Service Letter No. 305

October 1, 1958

MODEL AFFECTED: PA-24 Comanche, Serial Numbers Listed Below

DOOR LATCH MODIFICATION	
SKETCH "A"	S.L. #305
PIPER AIRCRAFT CORPORATION	
LOCK HAVEN, PENNSYLVANIA

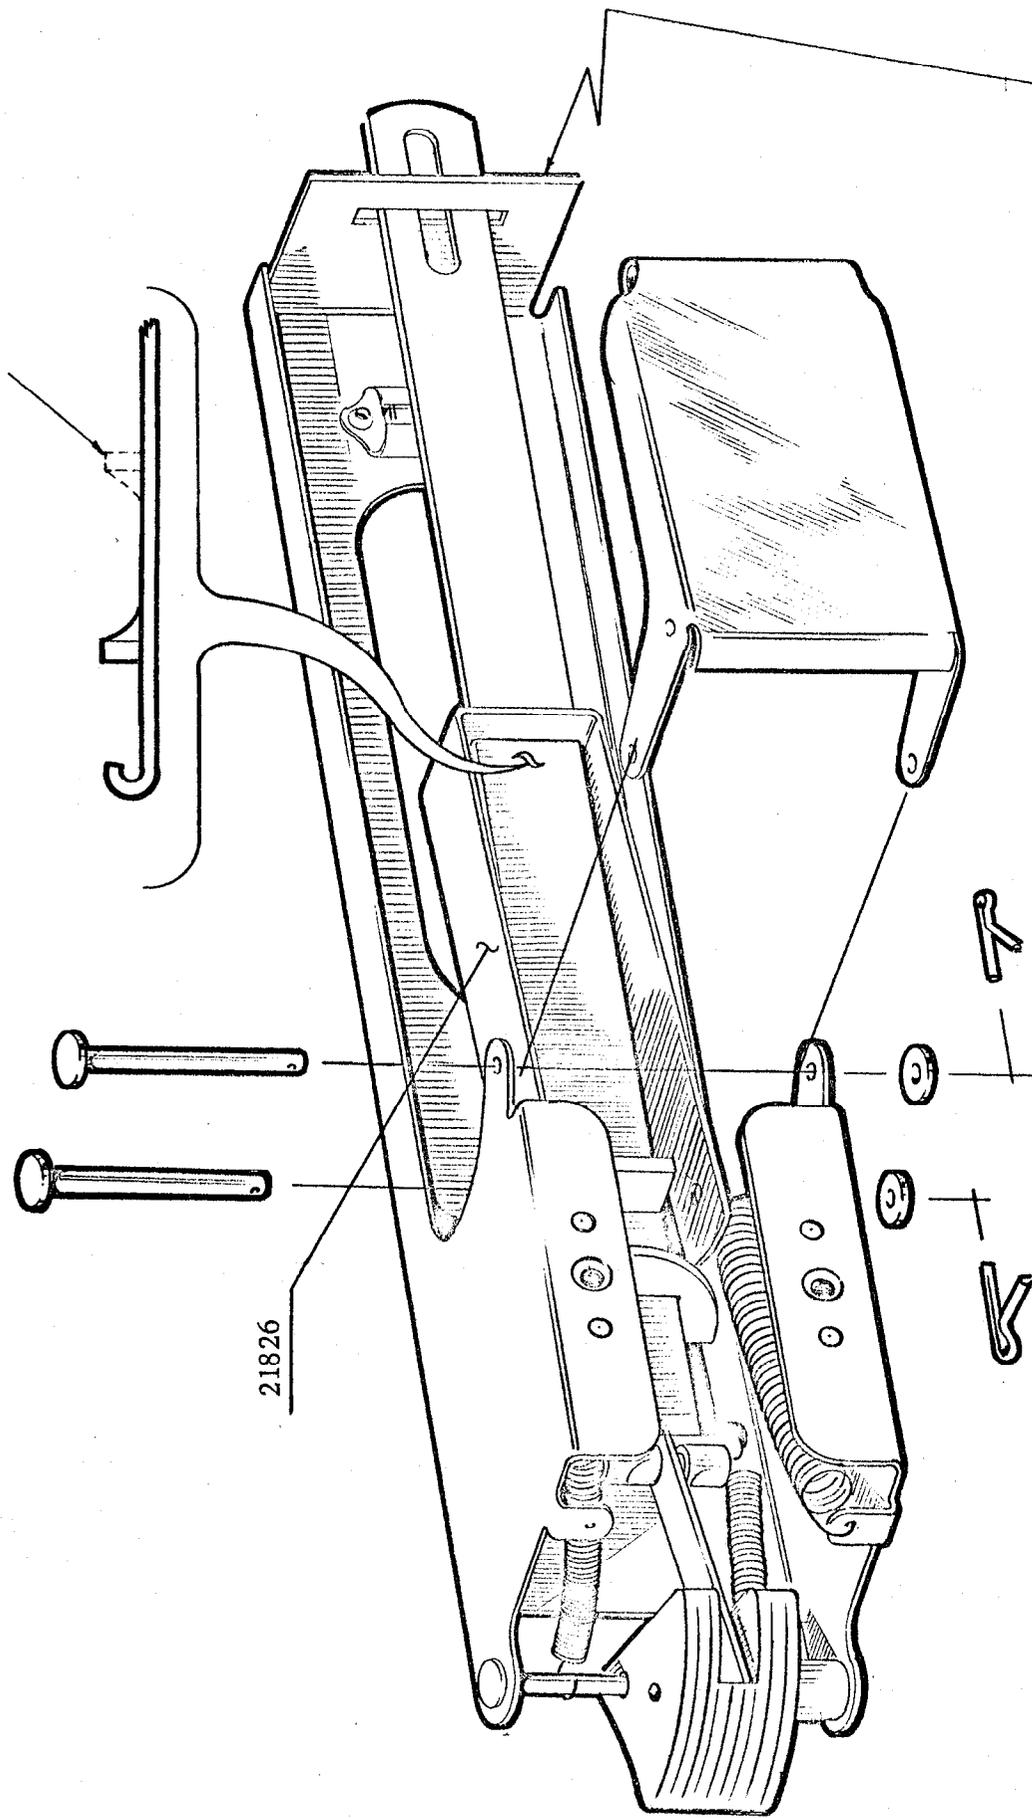
1. The main cabin door latch has been modified to provide a positive means of opening the door from the inside when it has been locked from the outside. We suggest that your door be revised as follows. Remove door latch assembly by loosening door trim upholstery and removing screws attaching latch plate and latch assembly to door frame. Disconnect latch pull rod from inside door handle and remove complete latch assembly. Modify latch assembly per Sketch "A" attached to this letter and install a new part number 21826.

BEND BACK TO LIBERATE
 END OF ACTUATING PLATE
 TO INSTALL PART NO. 21826

OIL SEPARATOR INLET HOSE MODIFICATION	
SKETCH "B"	S. L. #305
PIPER AIRCRAFT CORPORATION	
LOCK HAVEN, PENNSYLVANIA

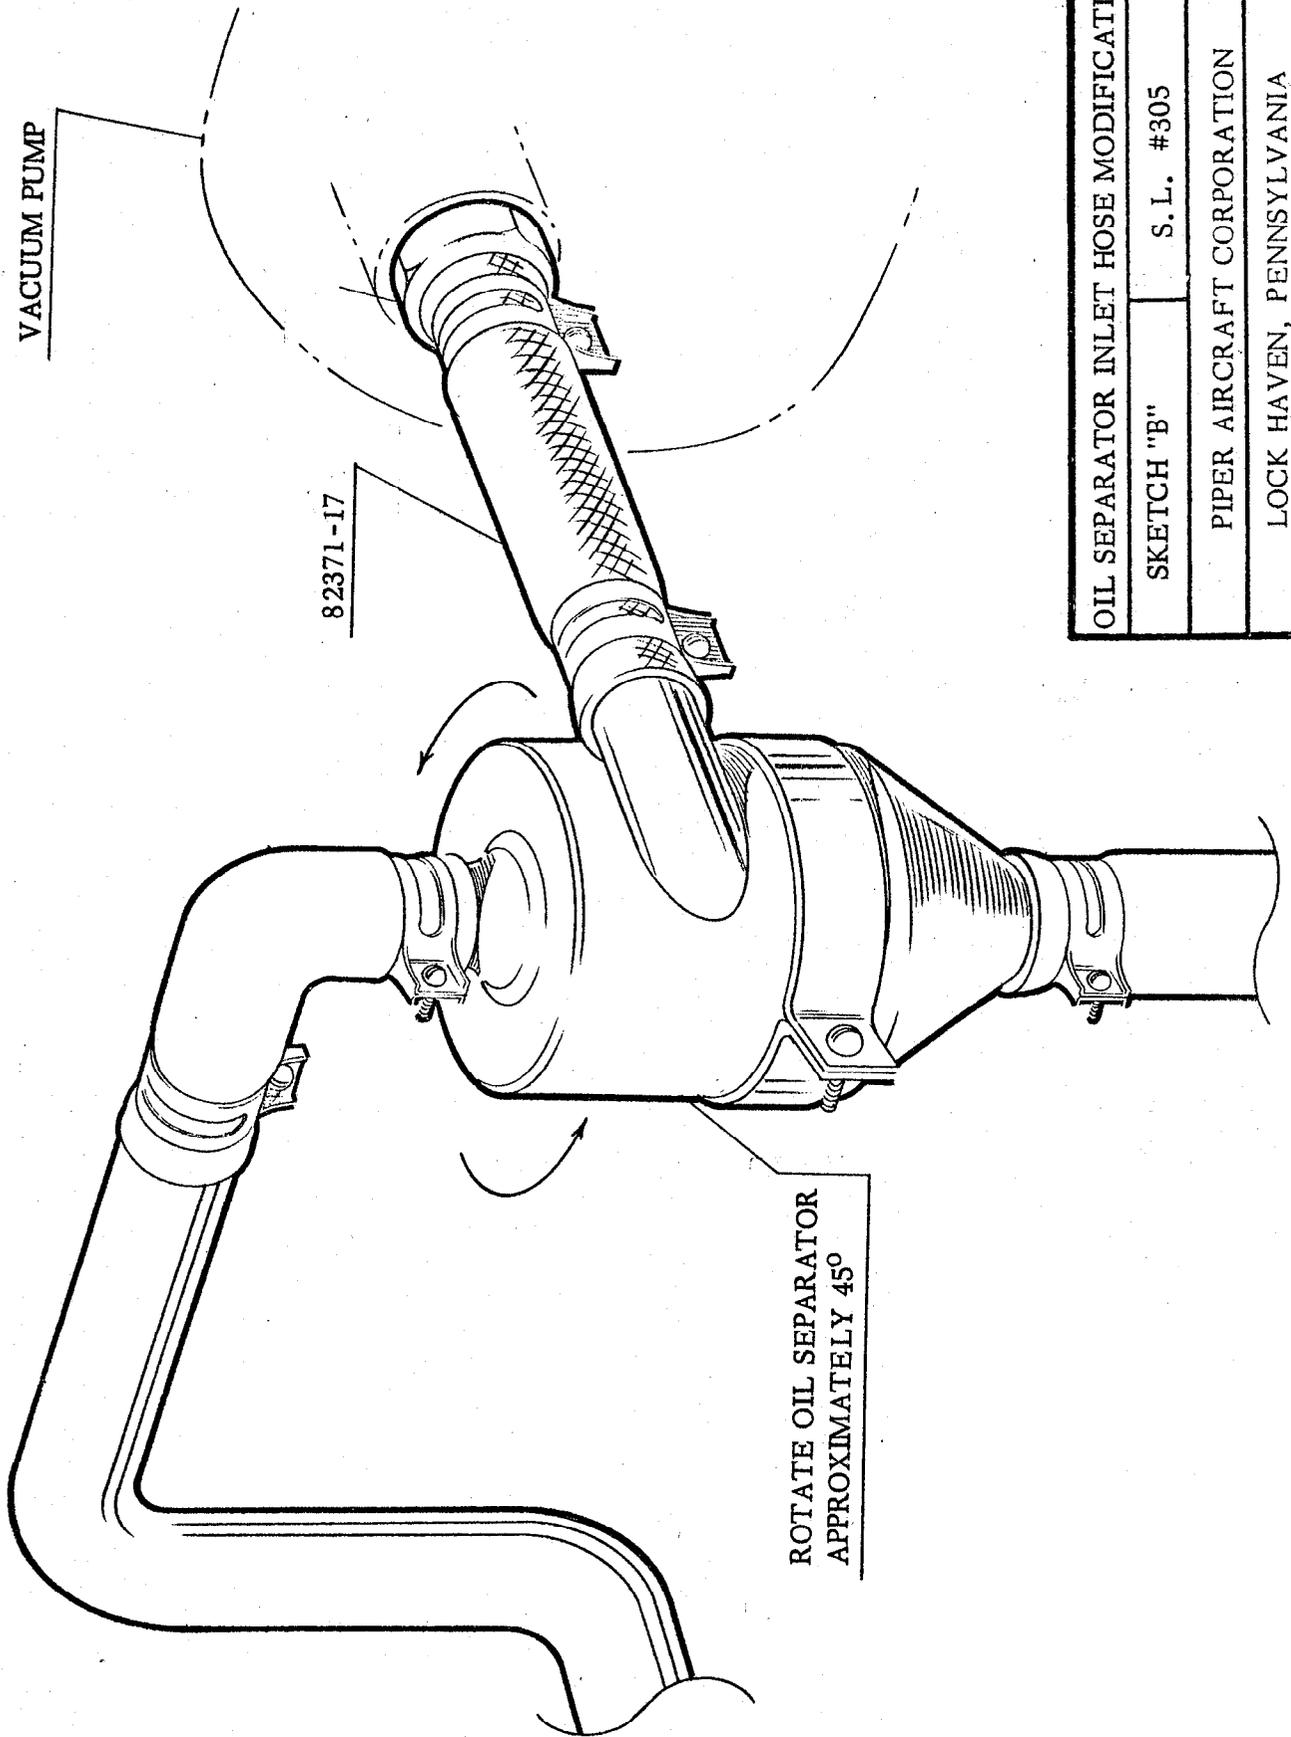
2. Rotate oil separator and install new hose part number 82371-17 and hose adapter part number 451 861 (AN840-9D) per Sketch "B" attached to this letter.

ROTATE OIL SEPARATOR
APPROXIMATELY 45°

L. G. Retraction Tube Arms Modification	
SKETCH "C"	S. L. #305
PIPER AIRCRAFT CORPORATION	
LOCK HAVEN, PENNSYLVANIA

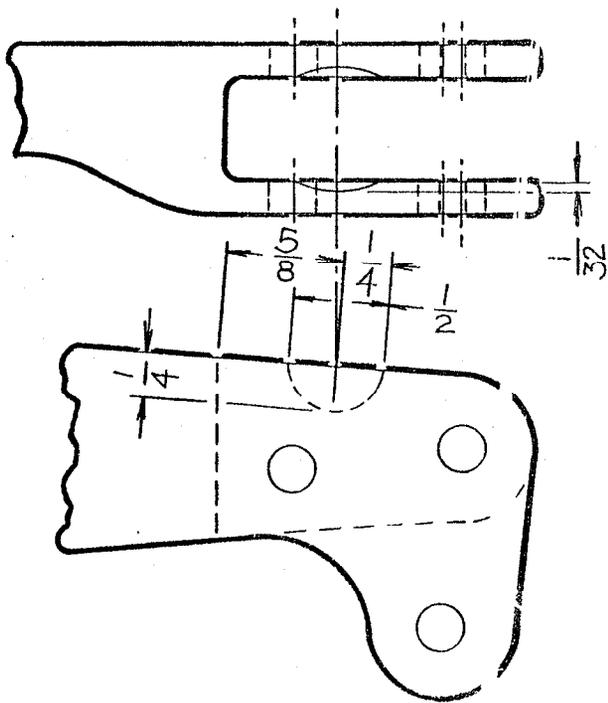
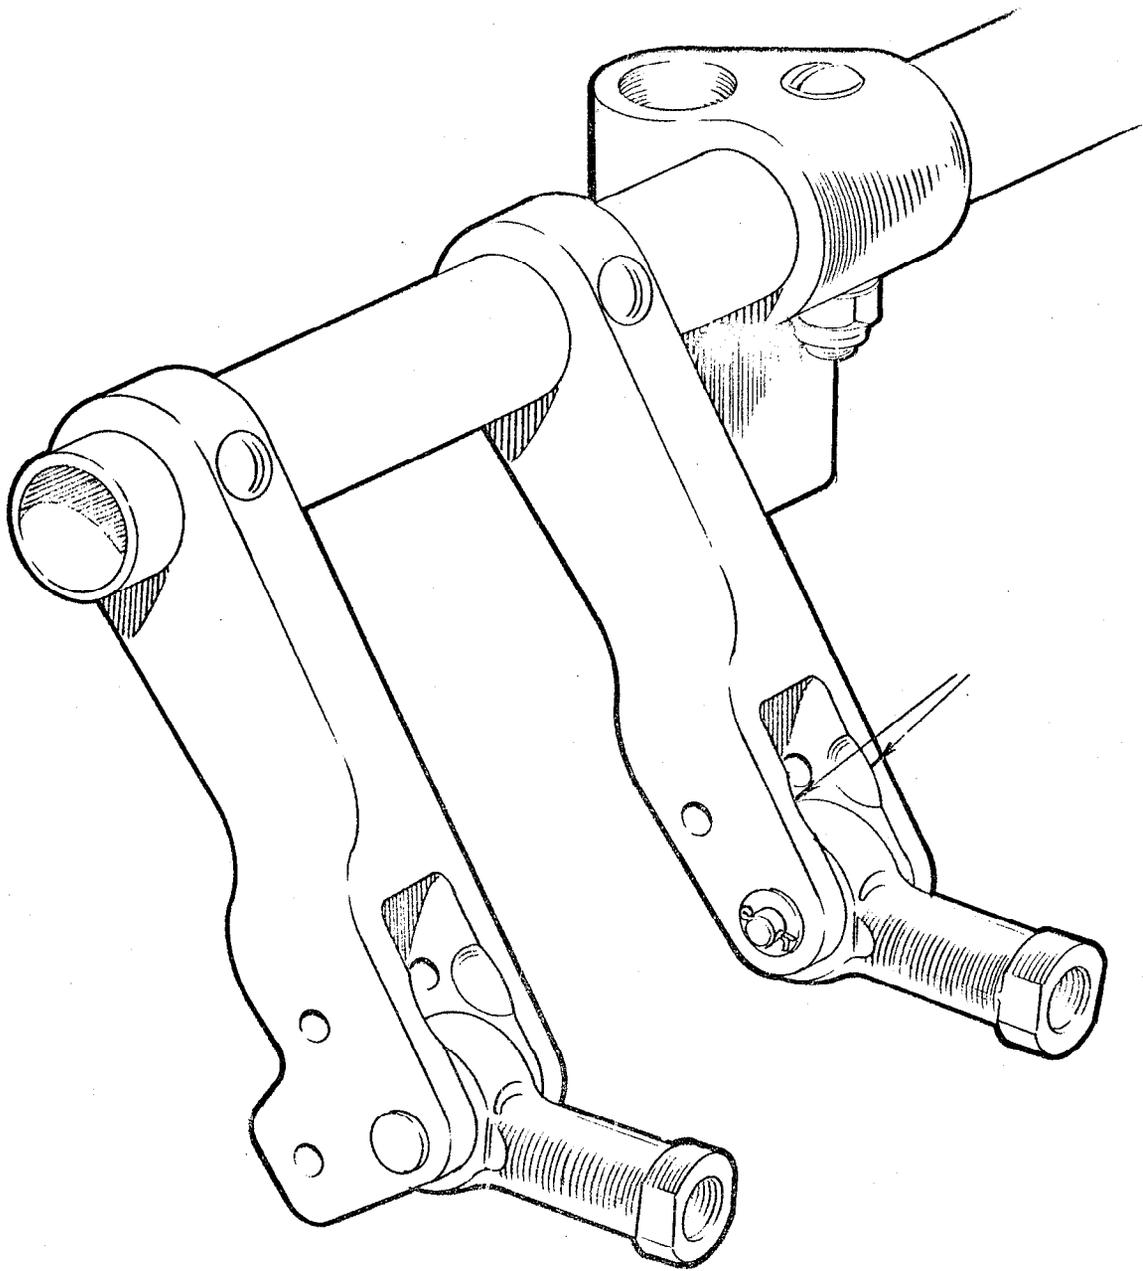
4. To prevent interference between the landing gear retraction tube arms and the retraction tube rod end bearings, the arms shall be modified per Sketch "C" attached to this letter.
